Paradise Business Centre

Lot 1, Block 1,
Paradise Valley Second Addition

Buildings 1, 2, 3, & 4

Revision Schedule		
△	Addendum	01/03/2025
△	Addendum	01/14/2025

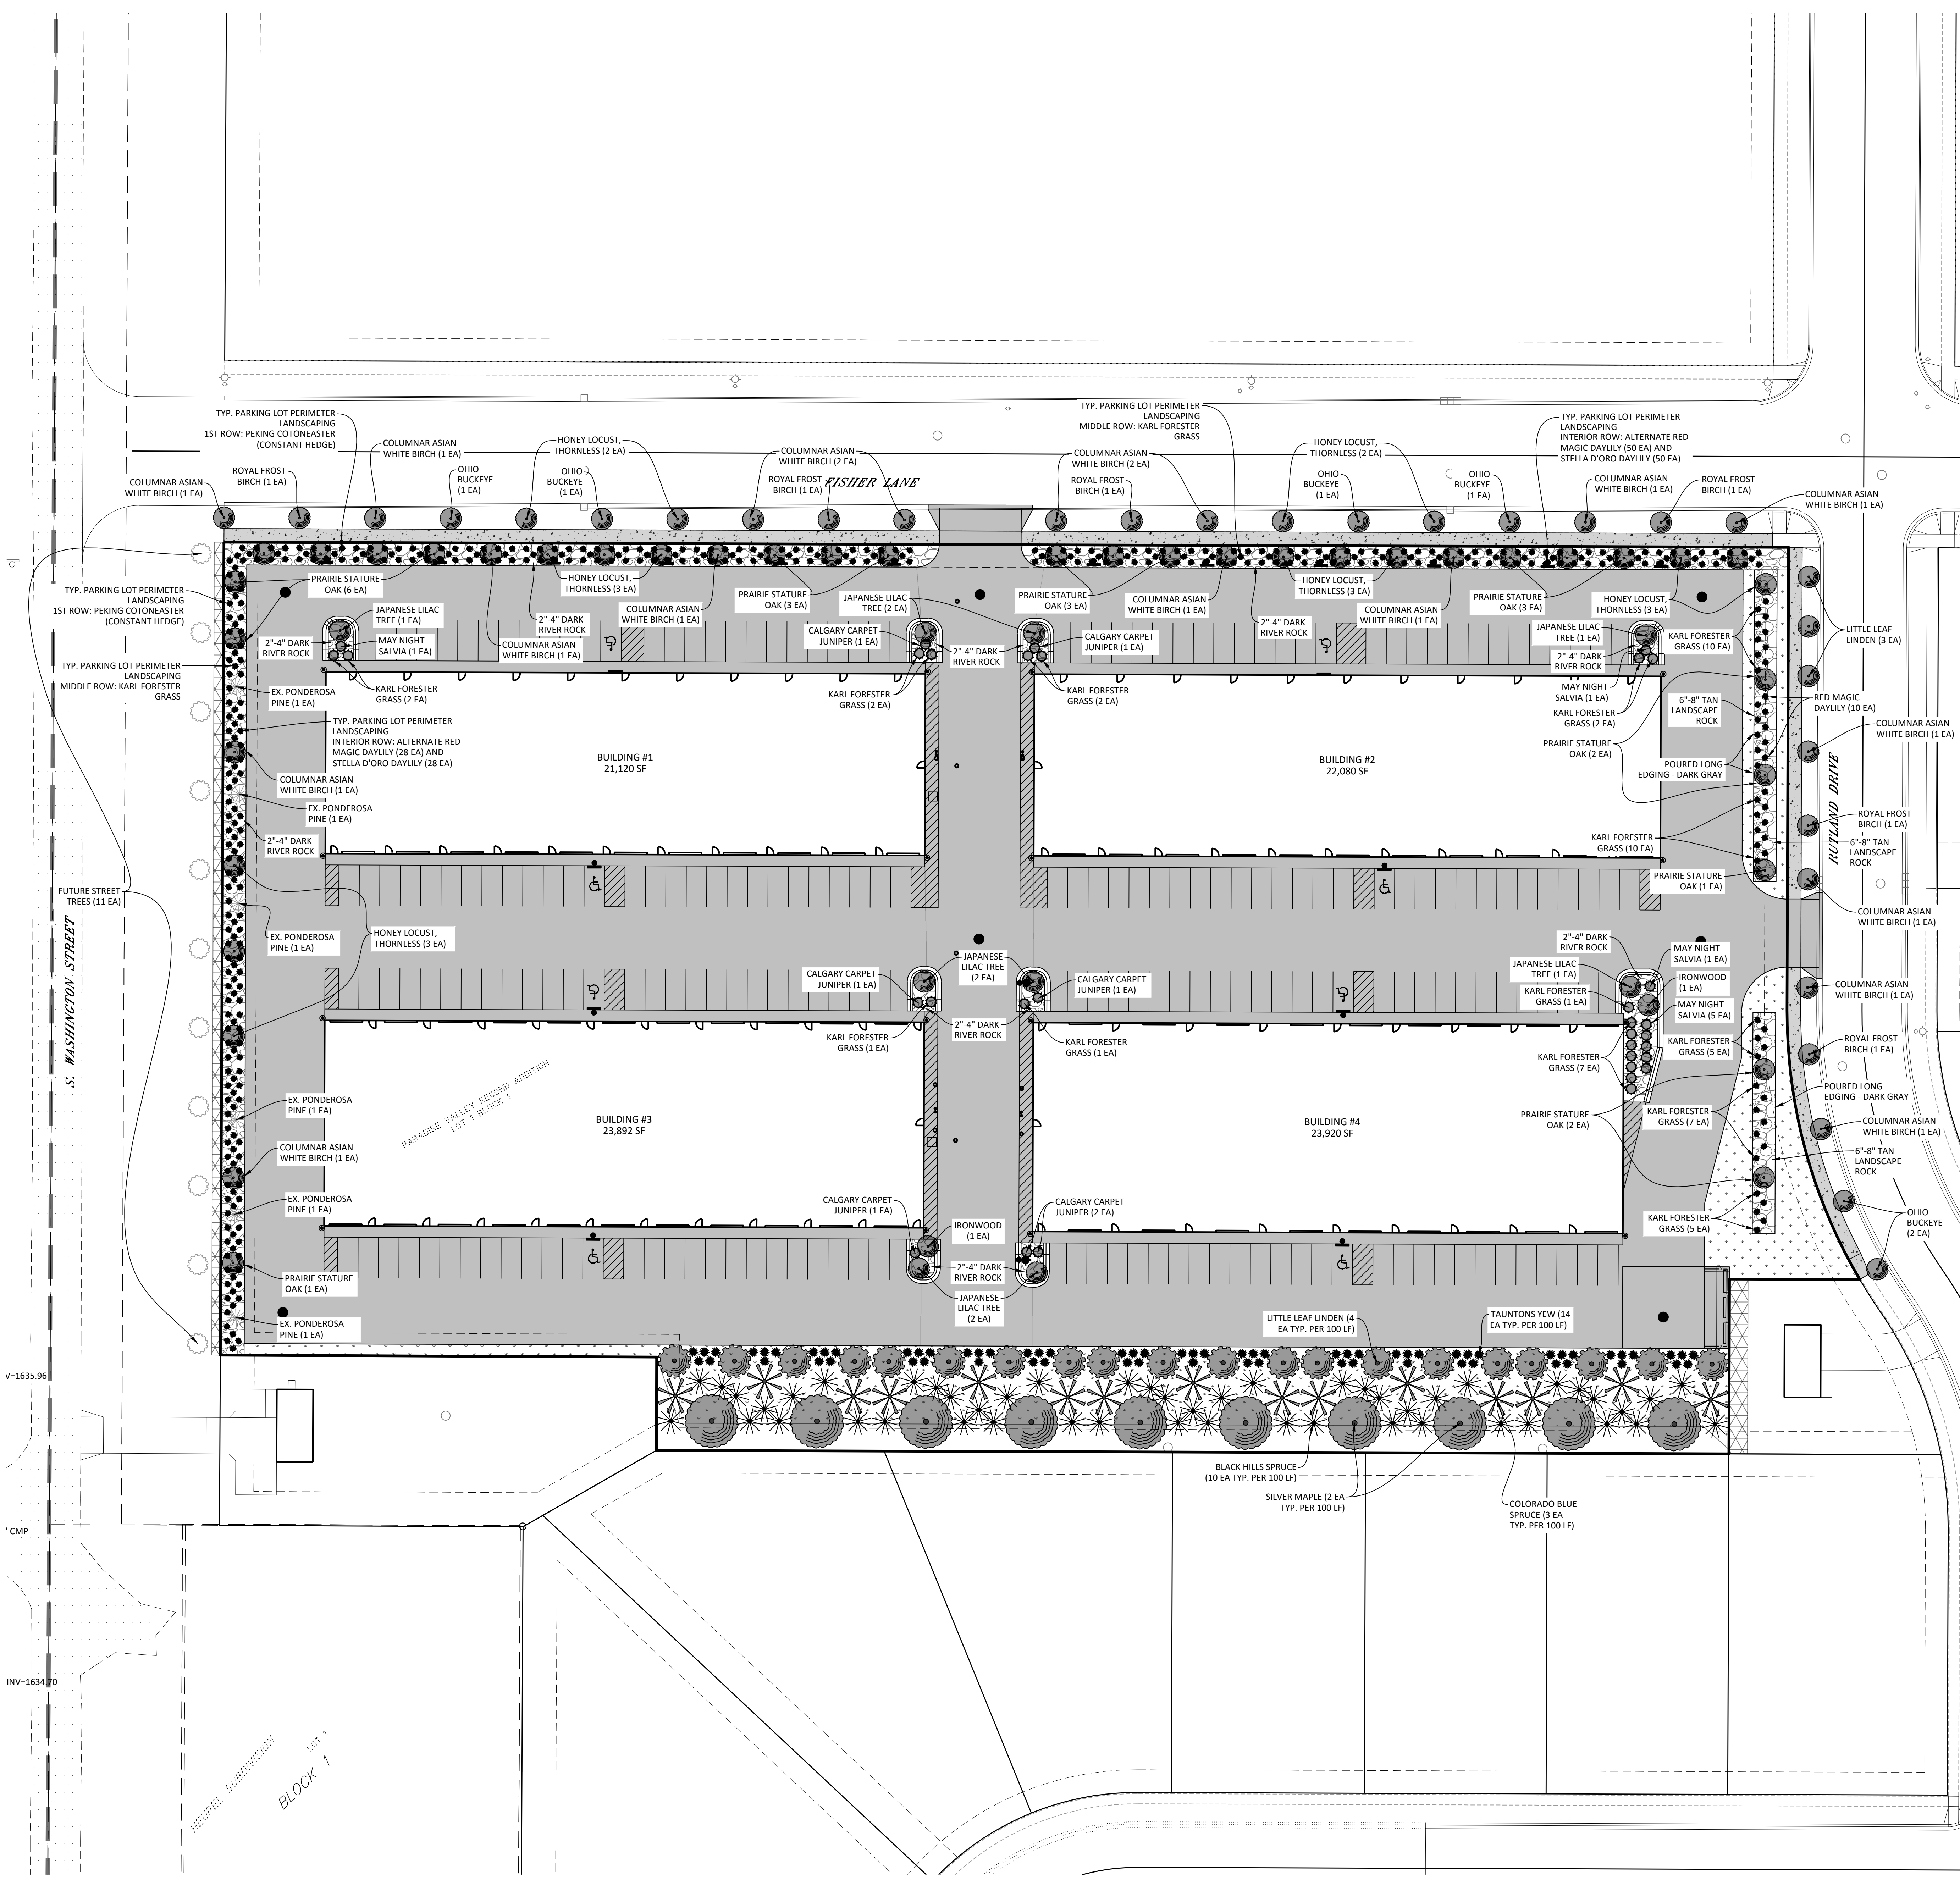
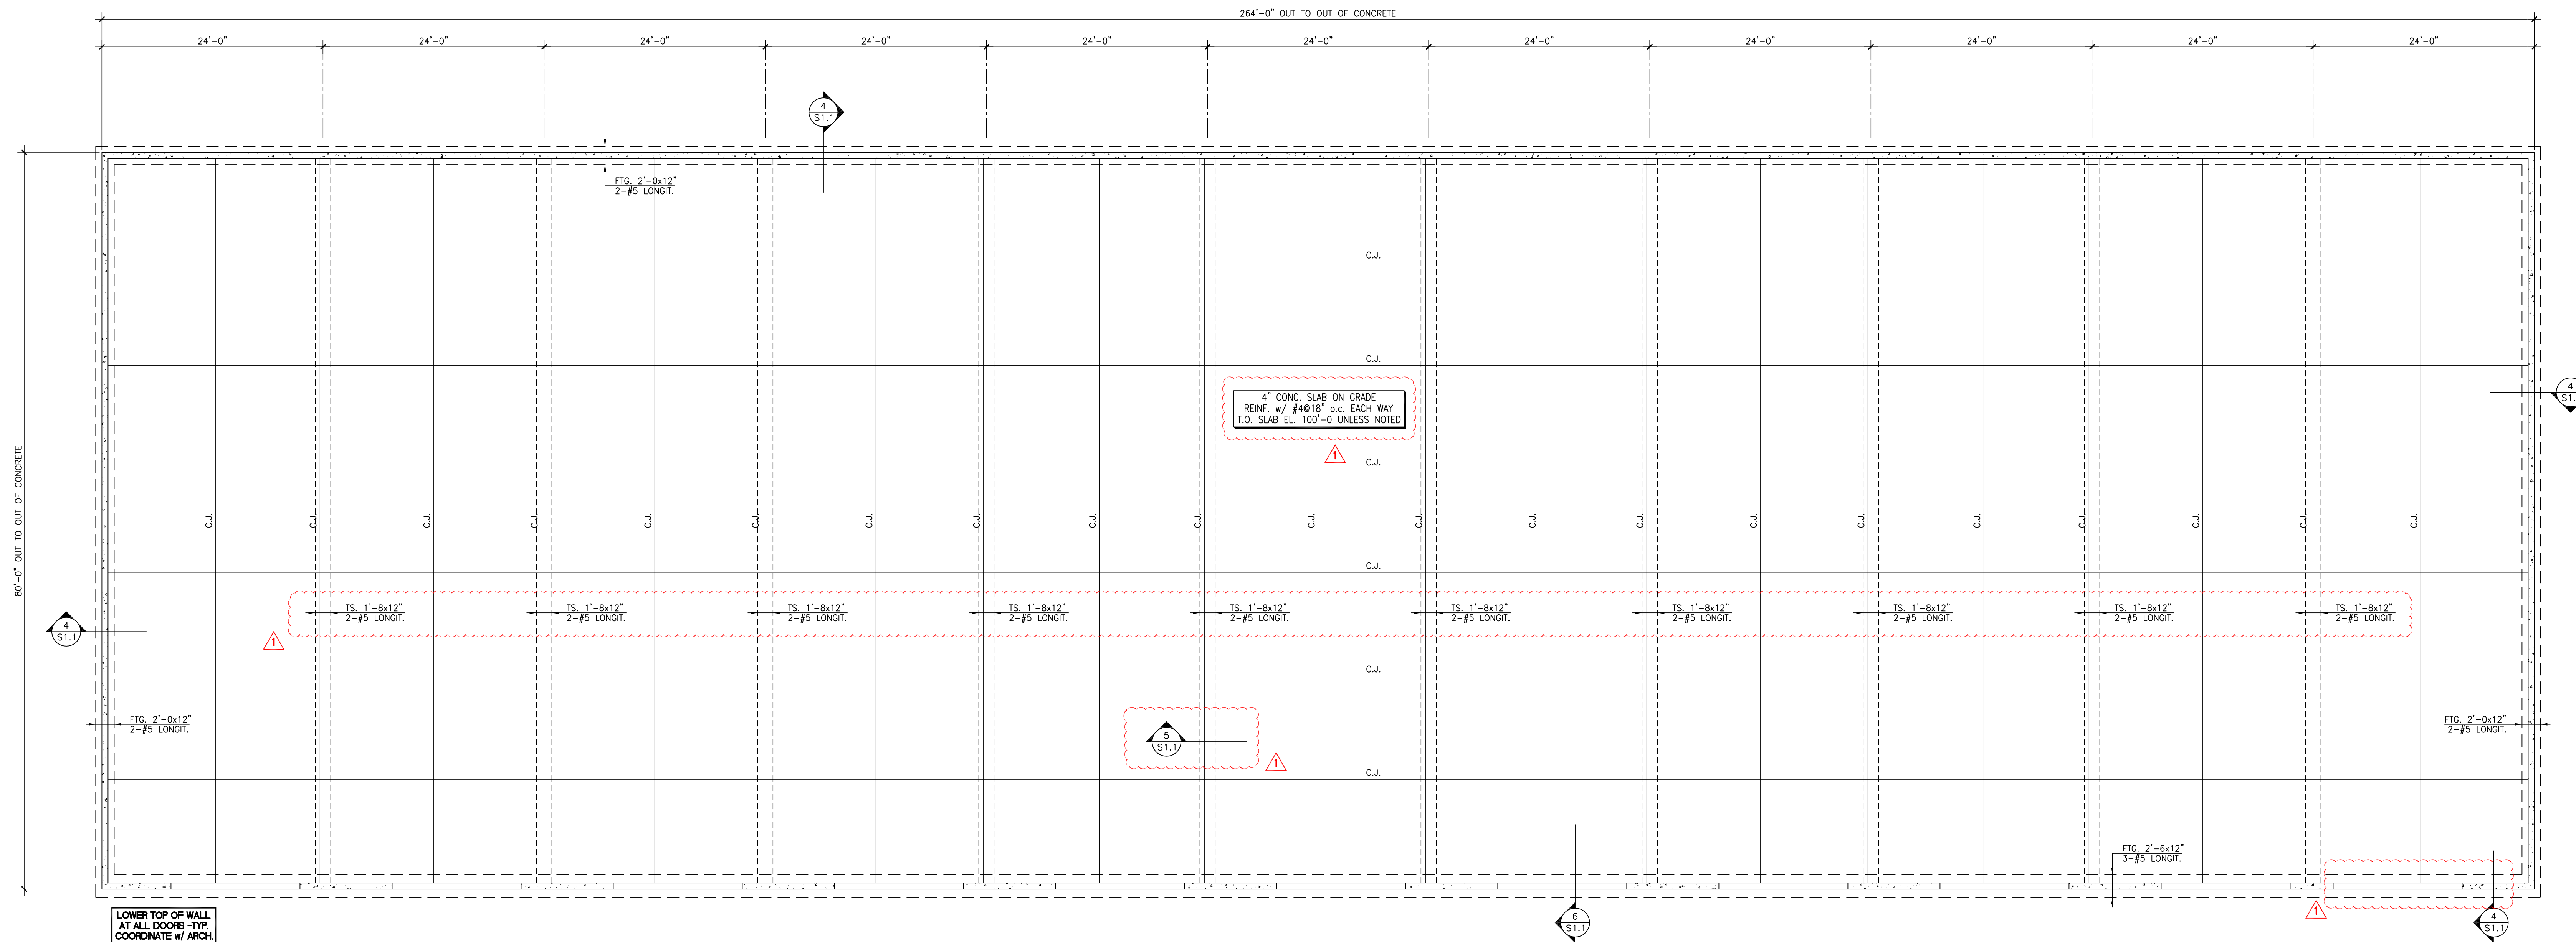
07/10/24 REVISIONS PER CITY COMMENTS
- ADD FUTURE STREET TREES ALONG SOUTH WASHINGTON STREET. UPDATE LEGEND AND CALCULATION TABLES ABOVE.
